PLANNING COMMISSION MEETING AGENDA

AUGUST 1, 2023

1. LSDP: Oakdale Middle School Addition

2. LSDP: Ritter & Spool

SITE UTILITY PLAN

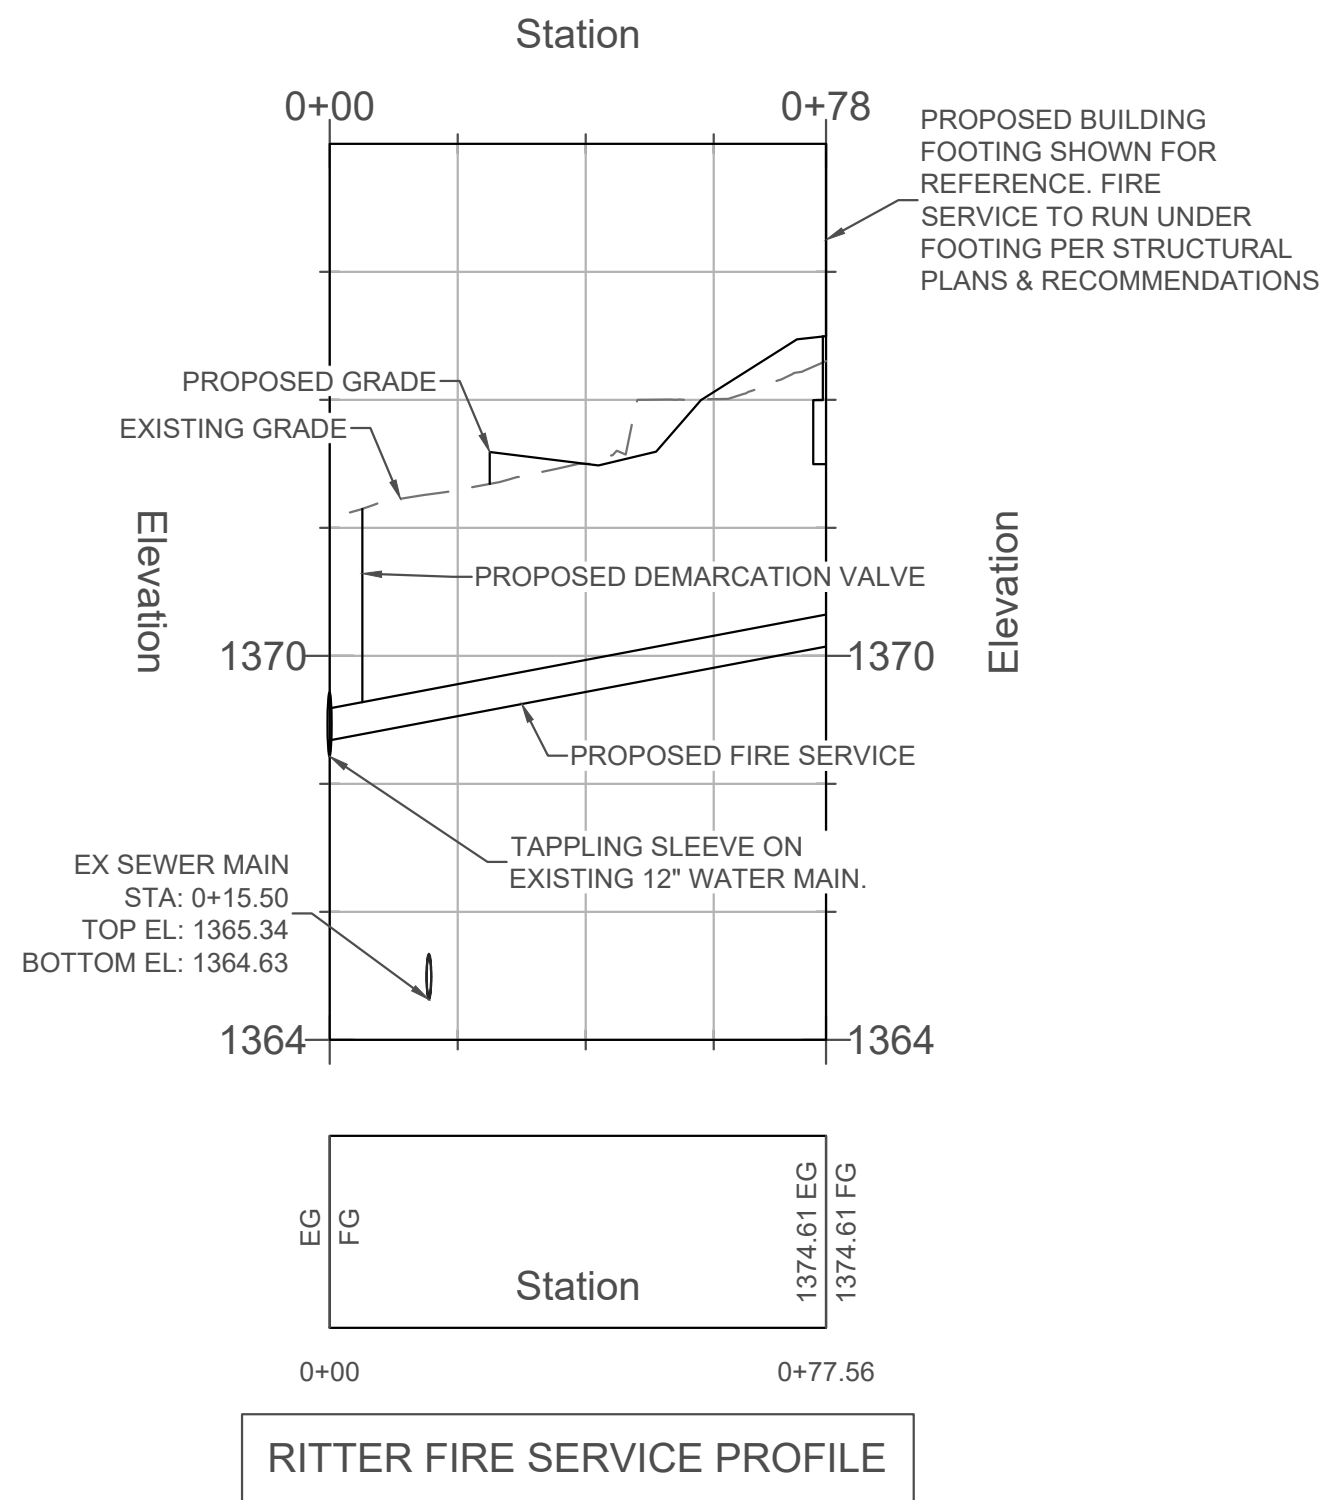
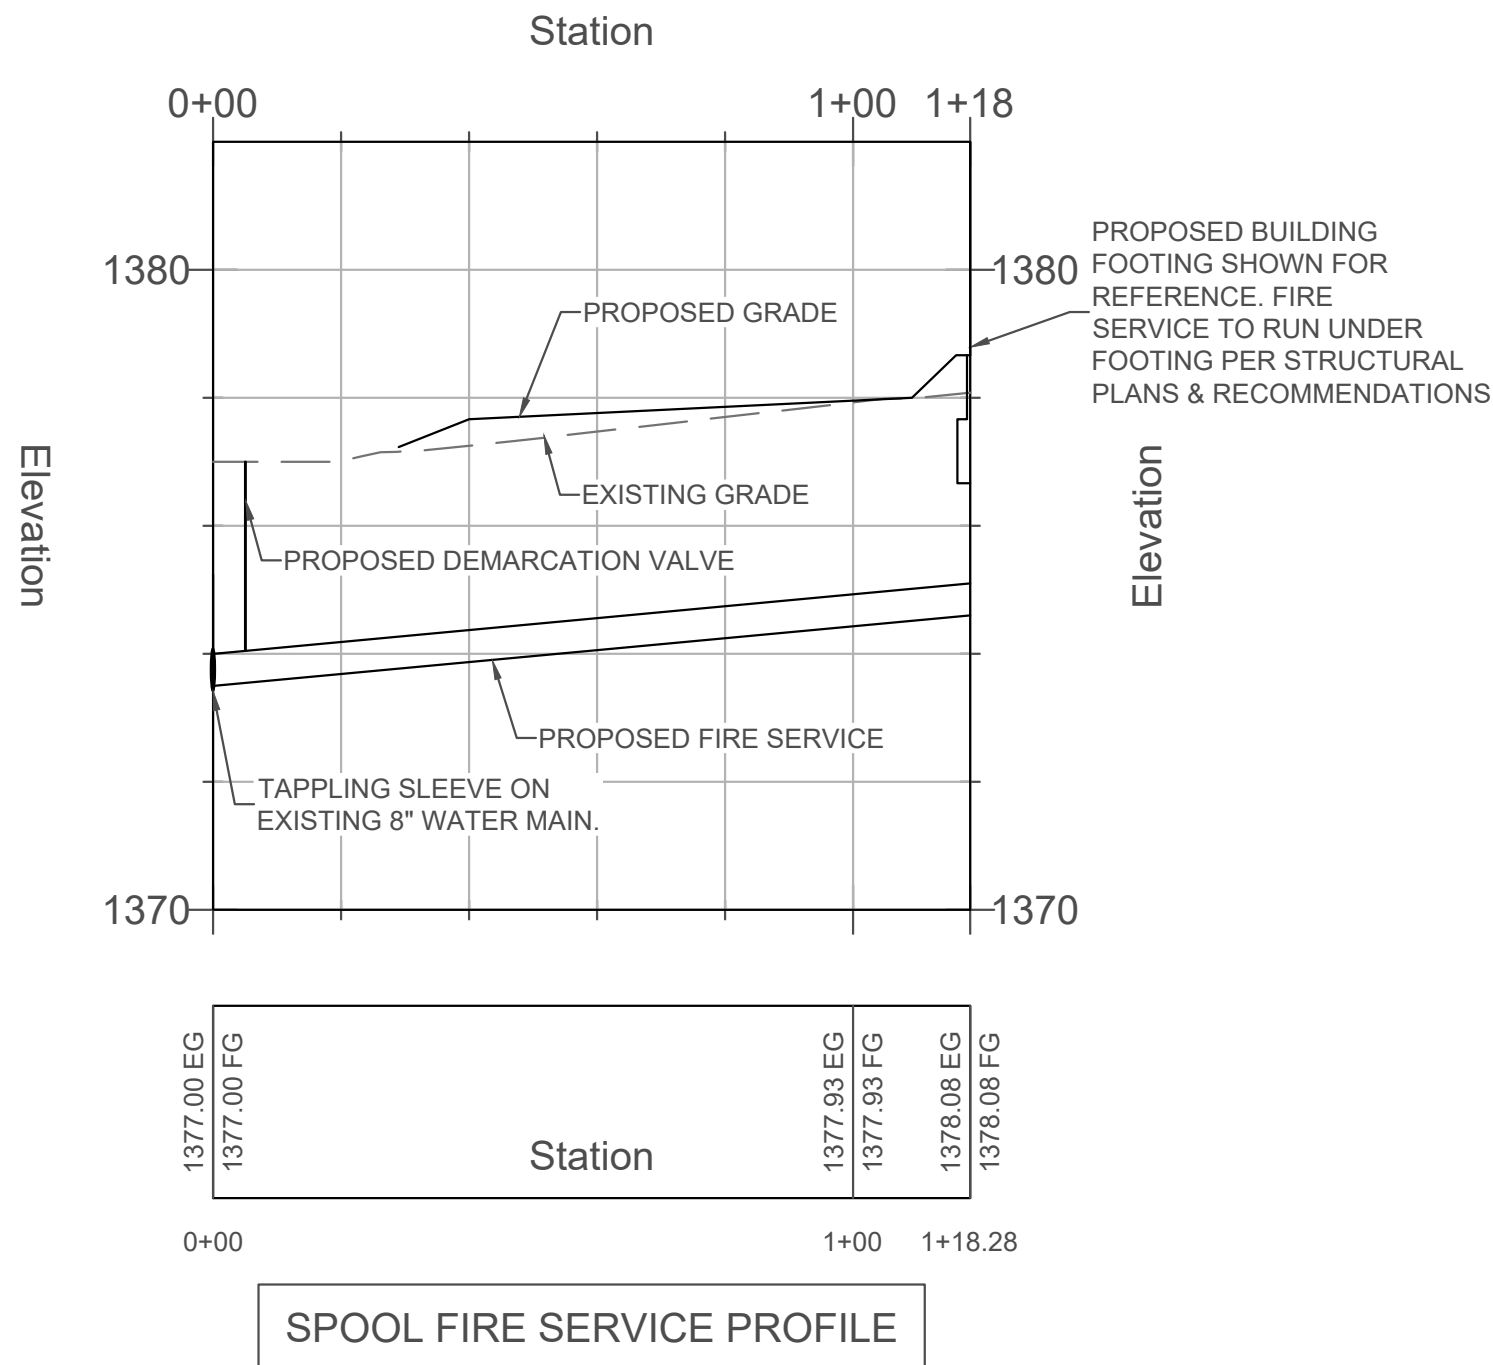
1. The sizes of the proposed fire lines must be shown on the civil plans.
2. Show and identify the proposed RPZAs on the Utility Plan as well as on the Landscape Plan.

3. Show the manhole rim and invert elevations for the manhole where the sewer for the Spool building discharges. Match crowns of the sewer service pipe with the outflowing pipe out of the manhole.

4. Show the upstream and downstream manholes when a new manhole is placed over an existing sewer main, along with rim and flow-line elevations.
5. When connecting a water service to an existing main note on the plans that RWU will construct the water meter service at the developer's expense (including irrigation meters).

6. Show the building footings on the fire line profiles with the fire line extending past the footing and up to where the backflow preventer will be.
7. Depict the location of the sanitary sewer crossing on Ritter Fire Service Profile.

8. Show the model number for the irrigation RPZA on the reduced pressure backflow w/enclosure detail as well as on the landscape plan.
9. The RPZA model number shown on the landscape plan is not a lead-free model which is now required. Also, specify the strainer separately from the model number.

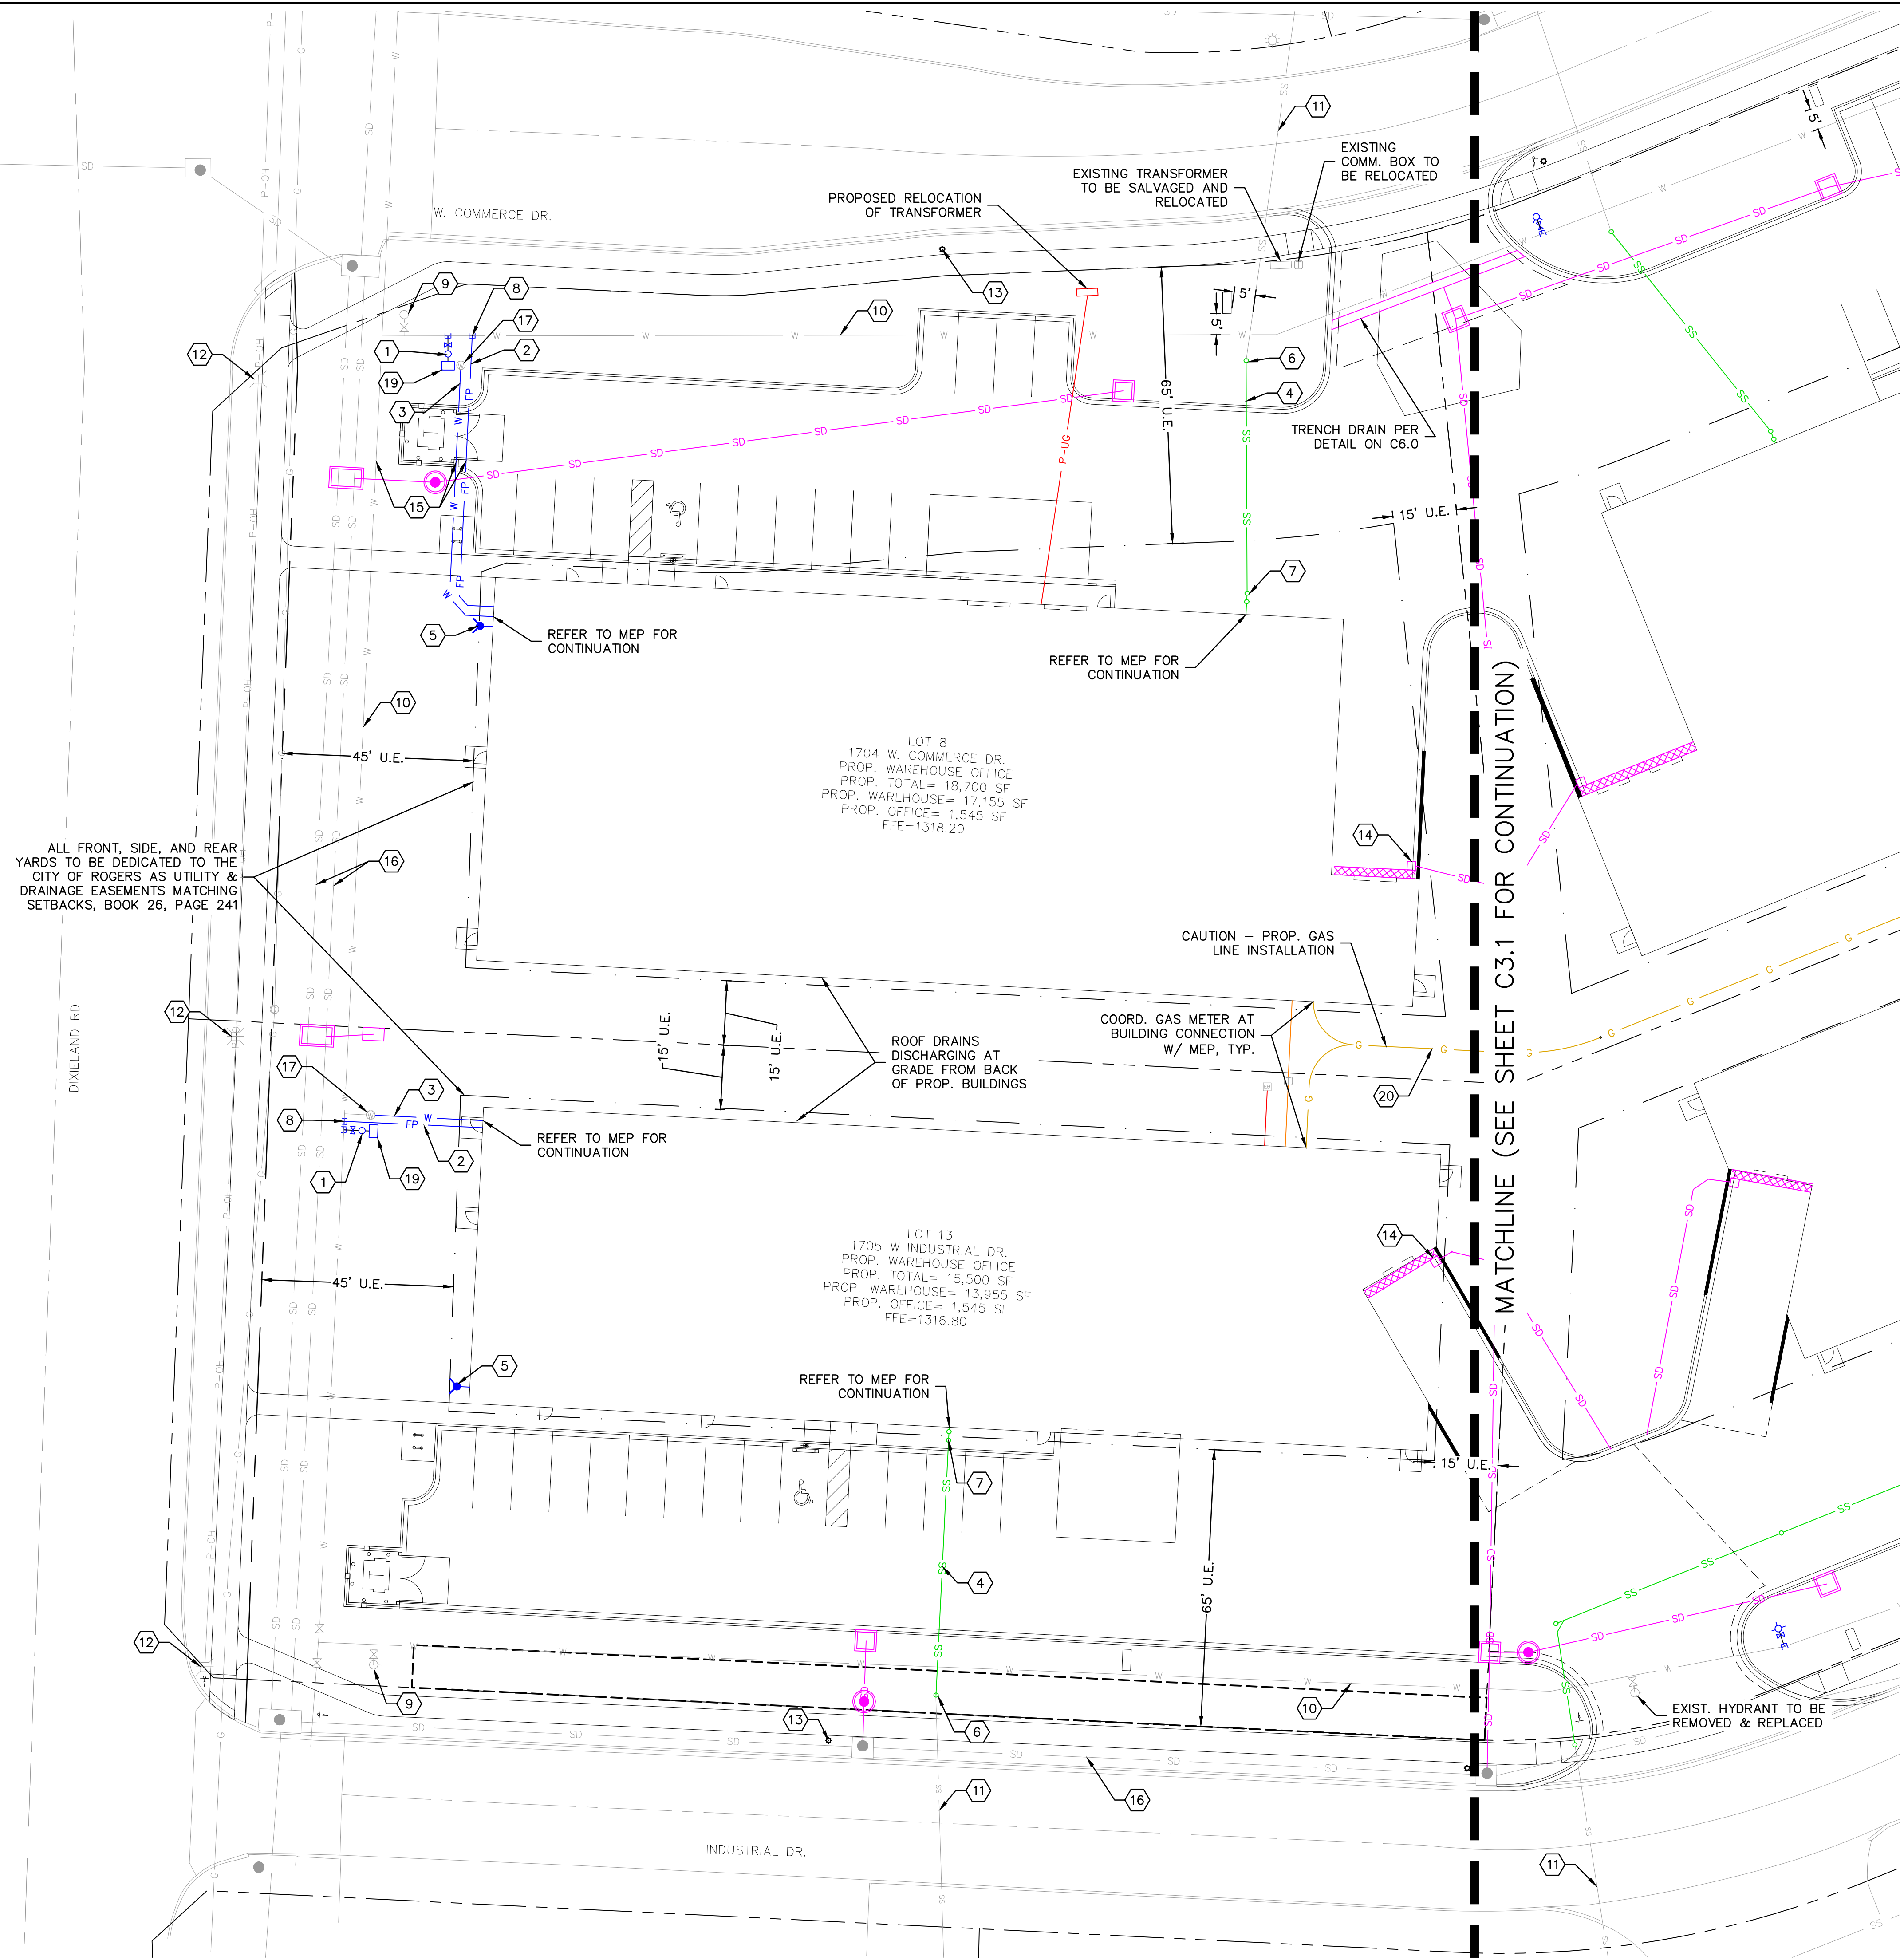
(Provide a detail for installation indicating manufacturer, model number--complete with all suffixes and prefixes, size, and installation orientation must be shown).

7. Large Trees (over 20' tall at maturity in City Code 14-46-paragraph G) must be located at least 10 feet from any water or sanitary sewer main. (this will include private fire lines)

SECOND HALF OF COMMENT
#6 ADDRESSED NOW,
SPEC. INFO. & DTL. ADDED
TO PLANS (SHEETS C3.0,
C3.1 & C6.0)

DETAIL ADDED TO SHEET
C6.0 OF REVISED PLANS
